CONTRACT
67

AGREEMENT

WELL DRAINAGE

N.W. - S.W. - NE Sec. 19-10 17

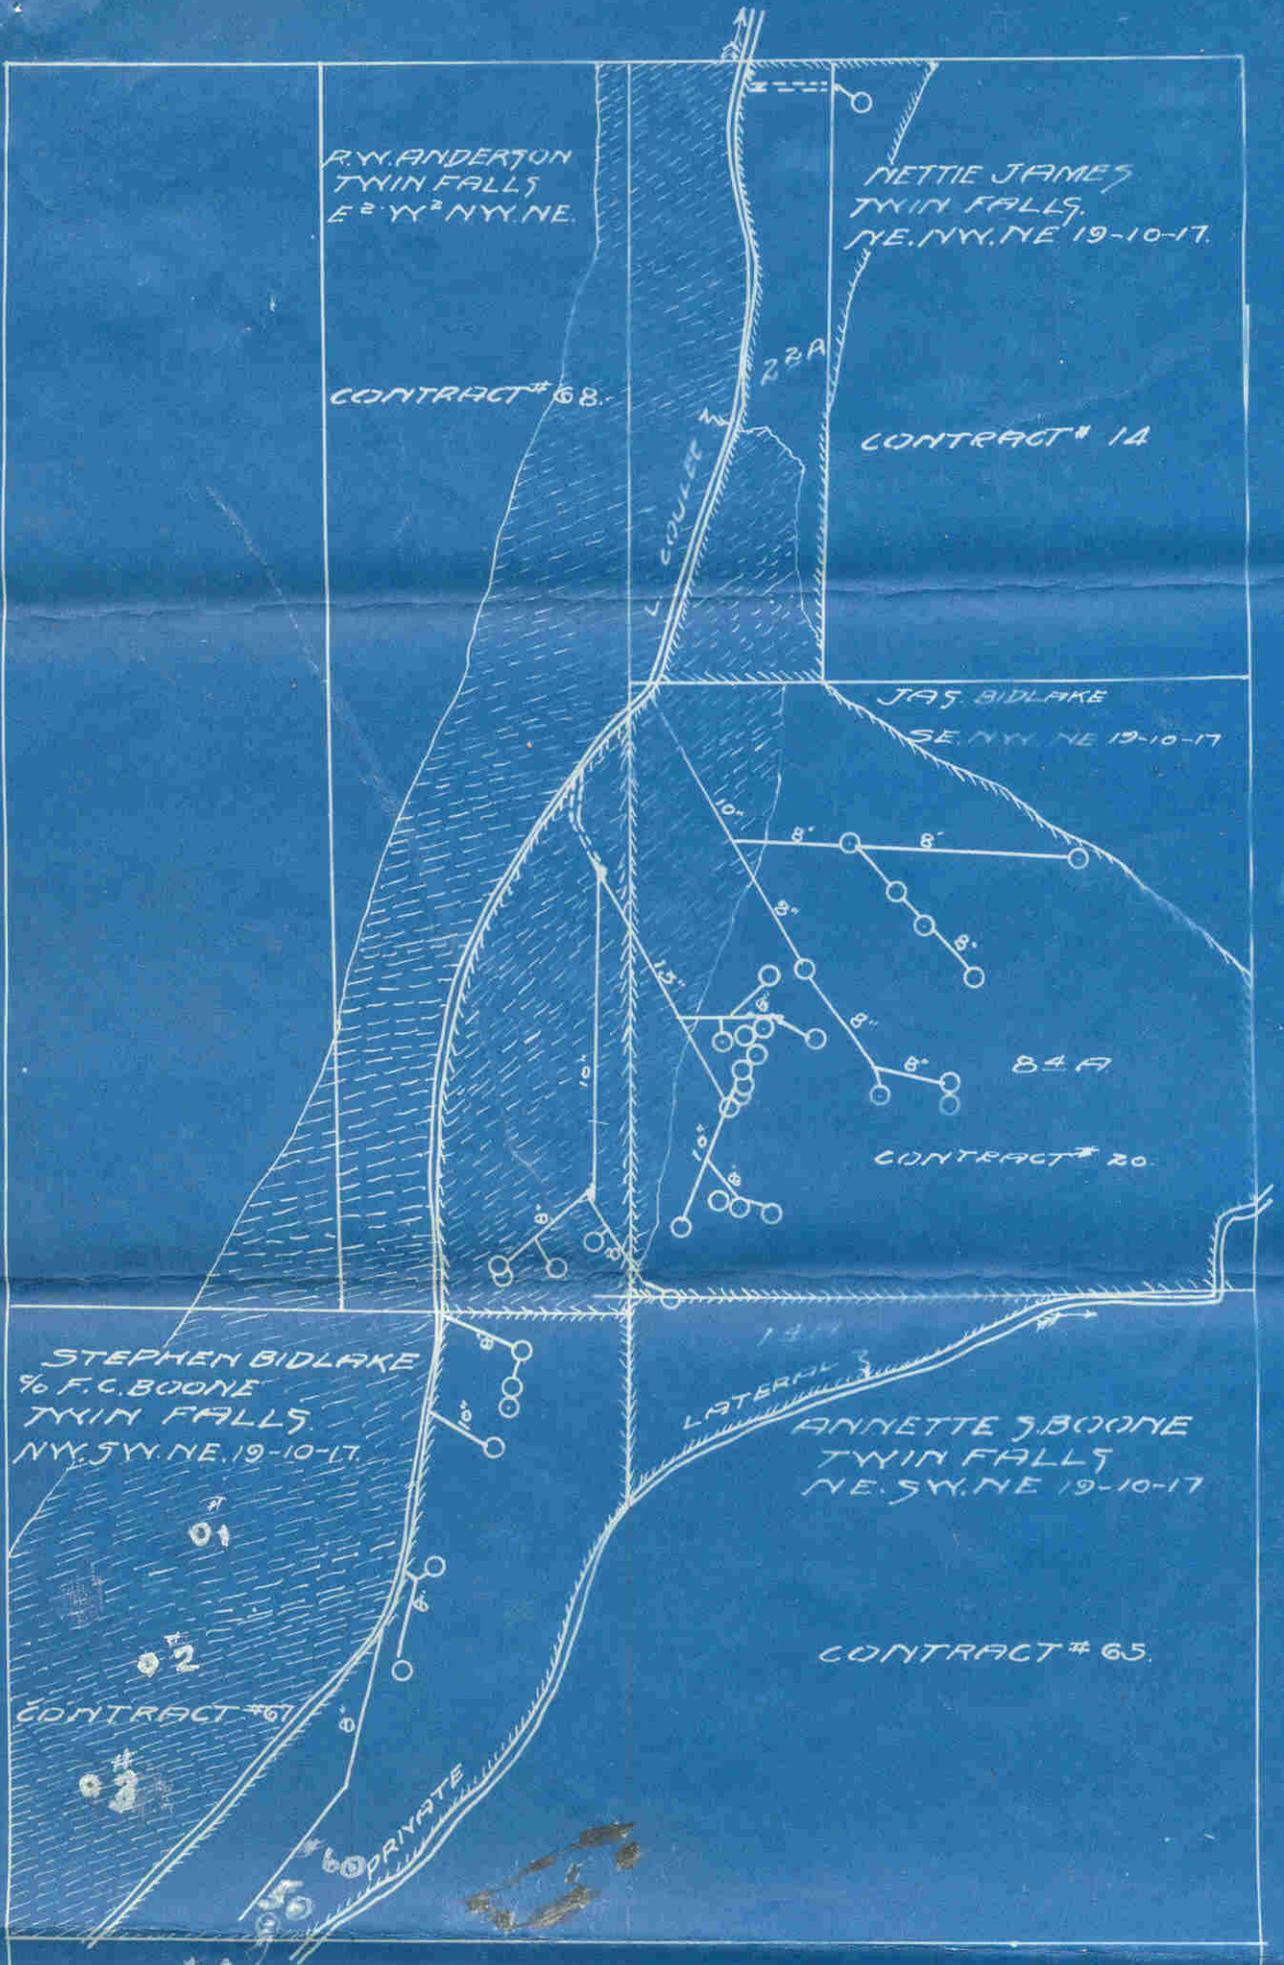
The land is dry on the surface and has some crop of alfalfa tho it is not entirely reclaimed. Mr Boone says that the water-table rises to very near the surface on both sides of the coulee.

The water in wells drilled is as follows

Well #	1	- to water	2' 1"	from surface
"	# 2	" "	2' 4"	" "
"	# 3	" "	3' 3"	" "
"	# 4	" "	3' 8"	" "
"	# 5	" "	4' 0"	" "
"	# 6	" "	6' 6"	" "

Well no 6 is on higher ground than the others. none of these wells are tiled so are doing no good.

The tile line of 8" tile is too near the surface to do any good and had no discharge.

It is my opinion that the coulee should be cut out lower and the wells topped at a lower elevation.
